Review of Long-Term Maintenance Plans for the South Jetty, Grays Harbor, Washington

by *Special Subcommittee of the Committee on Tidal Hydraulics and
Coastal Engineering Research Board*

Final report

Prepared for U.S. Army Engineer District, Seattle
Seattle, WA 98124-2255

Figure 20. Direct beach nourishment alternative

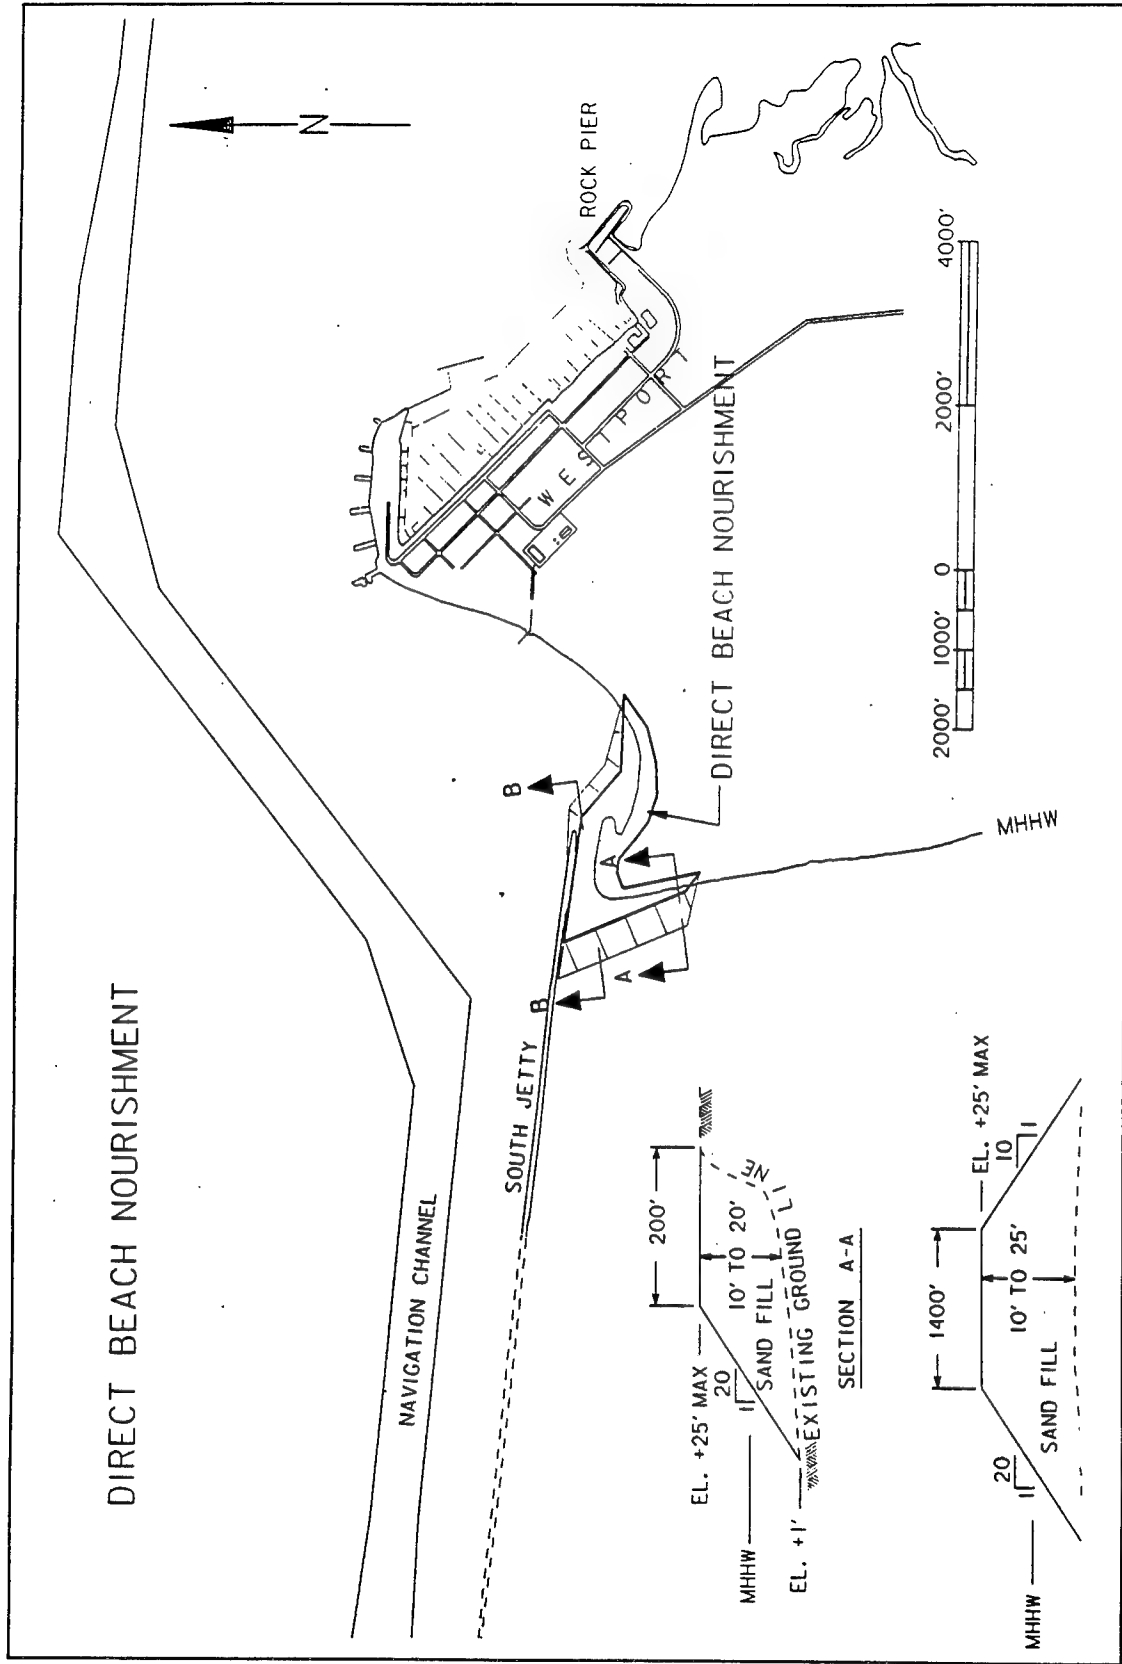
51. Placement of dredged material directly on the beach in the breach area as shown in Figure 20. The elevation of the top of the fill would be above that of the jetty to reduce the prospect of overtopping and to allow for settlement, and the width in the direction of the breach would be nearly twice that of the pre-breach sand neck. The eastern edge of the should extend from the eastern end of the jetty as shown in Figure 20 to protect the park facilities from erosion by waves diffracted by the end of the jetty. Approximately 500,000 cy of suitable material is dredged annually from the Entrance, Pt. Chehalis, and South reaches that could be placed at this location at a cost of \$4 to \$5 per cubic yard above present maintenance costs. The quantity of material dredged from these reaches is becoming smaller each year as the system adjusts to the 1990 channel modifications. Additional material, in diminishing amounts, is dredged from the bar, but the cost of transporting it to the beach would be prohibitive. Timing of this alternative is subject to fishery concerns, dredging schedules, and weather. To be a viable long term solution, this alternative would require a commitment to supplement sand from diminishing maintenance dredging with material dredged for nourishment.
